Appendix Y

Response to Comments

Subject: [EXTERNAL] update of 1968 Operating Agreement

Figure 1. Simulated Hartwell (blue) and Thurmond (red) elevations in existing operation, A2.

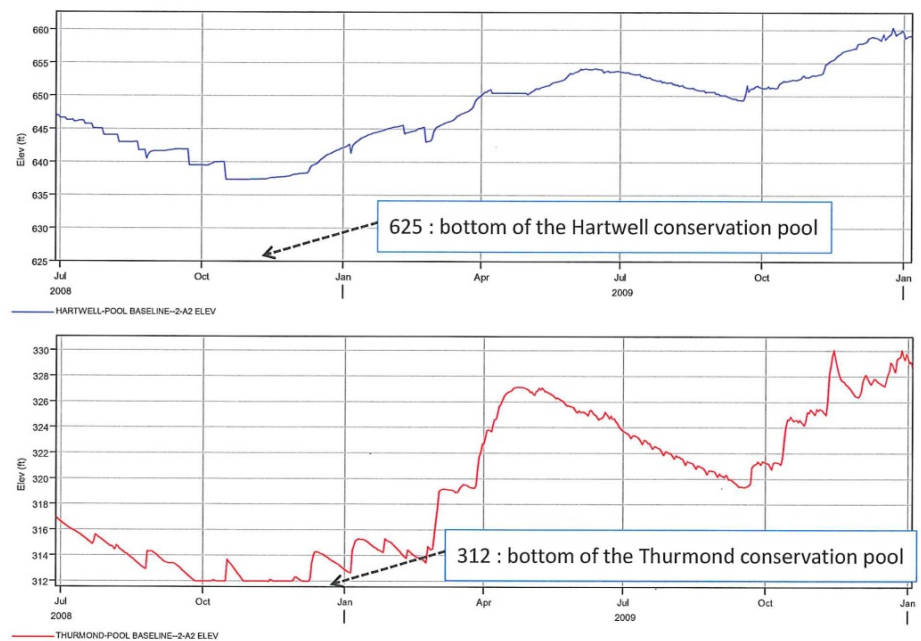
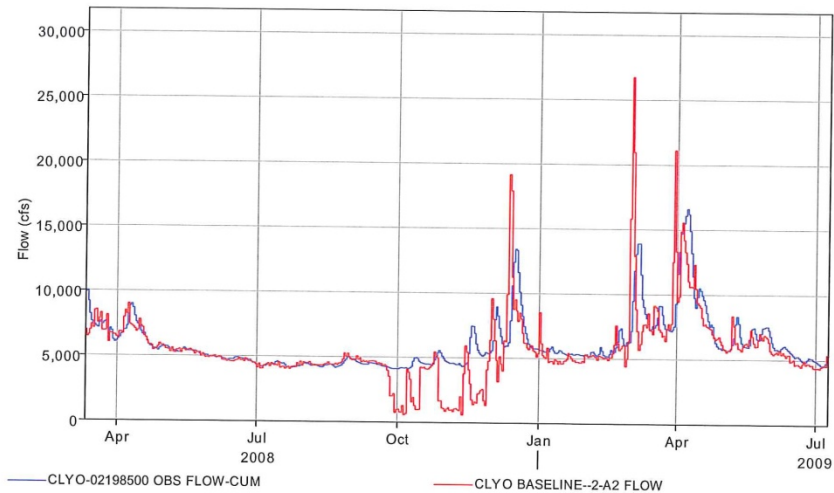
We believe there are certain settings and rules in the Duke Energy models that result in water elevation differences that are magnified. This may be due to truncation errors as a result of the number of time blocks used. For example, the upper conservation pool at Richard B. Russell is set at a depth of 0.01 feet. As a result, the operation of Richard B. Russell, when the lake is near the top of the conservation pool, can change significantly with minor changes in elevation. With an elevation change of only 0.01 feet, Richard B. Russell can move from the most conservative storage operation to a flood control mode of operation. If this occurs between different time-blocked simulations, minor elevation changes due to truncation errors may manifest into different operation rules that result in magnified differences.

Duke Energy's A2 modeling results include a period in the late fall and early winter of 2008 when releases from Thurmond are lower than the minimum flow requirement of 3100 cfs (or 3600 cfs depending on the Corps storage status) for 52 days. Based on this simulation, Thurmond's conservation pool is entirely depleted; while Hartwell is 12-15 feet above the bottom of the conservation pool (see Figure 1). This results in the predicted flows at Clio to be as low as 591 cfs (Figure 2). This could result in serious water quality implications in the lower Savannah River and Savannah Harbor.

Several problems have been identified. First, when water remains in the federal reservoirs' conservation storage, there should not be any flow violations. In this case there is water in Hartwell, yet the flow requirement at Thurmond has been repeatedly violated for almost two months. Second, the two large federal reservoirs (Hartwell and Thurmond) should not be out of balance. When there is plenty of water stored in Hartwell, Thurmond should not be at the bottom of its conservation pool. Thurmond should have been able to provide for its release requirements.

Response: The Corps reviewed the RES-SIM model results and found similar problems to that noted by EPD with the version of the model that Duke Energy used in its analysis. The District consulted with the originators of the program and identified several improvements to the model. The Corps reran the model for the No Action Alternative/A1, Alternative 2, and Alternative 3 using the improved model code. The new results are similar to those obtained by using the version that Duke Energy used. However, the model now performs much better at the boundaries where a reservoir changes from one drought level to another. The inconsistencies that EPD identified at those times have been corrected.

Response: The Corps reviewed the RES-SIM model results and found similar problems to that noted by EPD with the version of the model that Duke Energy used in its analysis. The District consulted with the originators of the program and identified several improvements to the model. The Corps reran the model for the No Action Alternative/A1, Alternative 2, and Alternative 3 using the improved model code. The new results are similar to those obtained by using the
